PRODUCT CHANGE | RB05-9359-xxx040

DISCONTINUED PRODUCT	REPLACEMENT PRODUCT	CHANGES MADE	
			YES	NO
DESCRIPTION.	Easy-Lock Gear - Small VX Inst. Brackets	Easy-Lock Gear – Small, RB09 LX Inst. Brackets	<input checked="" type="checkbox"/>	<input type="checkbox"/>
CODE.	RB05-8358-xxx040	RB05-9359-xxx040	<input checked="" type="checkbox"/>	<input type="checkbox"/>
PACK SIZE.	5 200 Sets	5 200 Sets	<input type="checkbox"/>	<input checked="" type="checkbox"/>
COLOR / FINISH.	Pure White	Pure White	<input type="checkbox"/>	<input checked="" type="checkbox"/>
LENGTH.	40mm Projection	40mm Projection	<input type="checkbox"/>	<input checked="" type="checkbox"/>
IMAGE.			<input checked="" type="checkbox"/>	<input type="checkbox"/>
USE WITH.	Gear Small, RB08 Idlers	Gear Small, RB09 Idler	<input checked="" type="checkbox"/>	<input type="checkbox"/>
TRANSITIONING.	September 2017

FUNCTIONAL IMPROVEMENTS

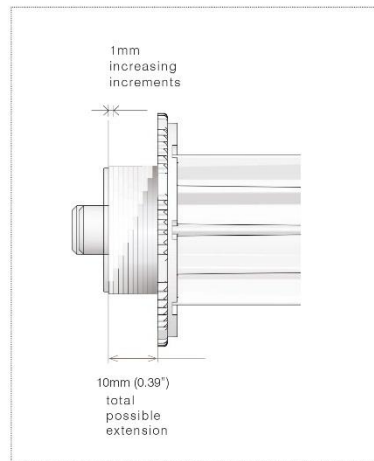
- Using the RB09 Pin control, the installer can adjust the component in 1mm increments up to a total of 10mm (0.39"). This allows for the best possible fitment in any installation.

AESTHETIC IMPROVEMENTS / CHANGES

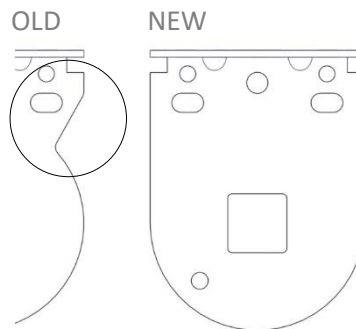
- Modified shape
